STAFF REPORT

Case #21-03: SPECIAL PERMIT FOR

Case #21-04: SPECIAL PERMIT FOR

115 Coggeshall Street Map: 86 Lots: 10

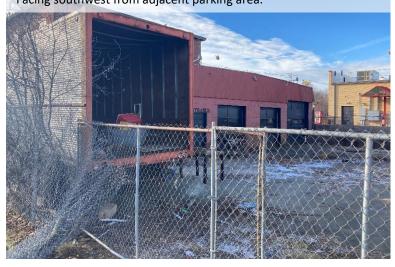
address concerns about the potential odor created by a Marijuana Retailer. The proposed location forgoes an engineered odor control system, and as required by the application, the applicant has provided a memo explaining why such a system is not needed. In the memo, the applicant notes that they do not "anticipate any specific odor-emitting activities associated with this use." The memo goes to note that no marijuana cultivation will occur on site and that all marijuana products will arrive to the site "pre-packaged and specifically sealed so as not to emit odors" and that upon purchase, products will be "repackaged in an exit bag to reduce any odor." The applicant also states that, once received, marijuana products will be immediately stored in a secure vault. The Board may wish to inquiry as to the characteristics of the vault relative to odor control.
